Access Compliance Report

Public Rights-of-Way

(Pedestrian Signals)

Intersection ID: N/A	Main Street:	Cross Street: N/A	Location: N/A
ADA ID: 10A00644B93E	Signal Type: One Push Button-APS	Overall Compliance: No	Severity Score: BTN 1: N/A BTN 2: N/A No BTN: N/A
Codes/Mitigation Info/Possible Solution		Field Measurements/Component Compliance

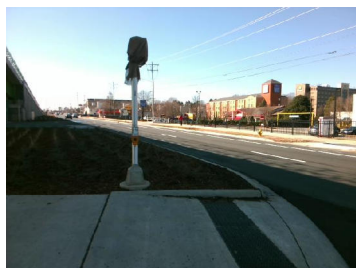
Surveyor Notes: NOT HOOKED UP, NOISES AND VERBAL COMMANDS UNKNOWN

PROW/ADA: TMUTCD 4e.08, R404.2, R404.7.3, R404.7.2, R209.1, MUTCD 4e.10, R104.2, MUTCD 4e.08,

Possible Solutions: Replace Signal Push Button With APS Button on New Post. Remove & Relocate Sign.
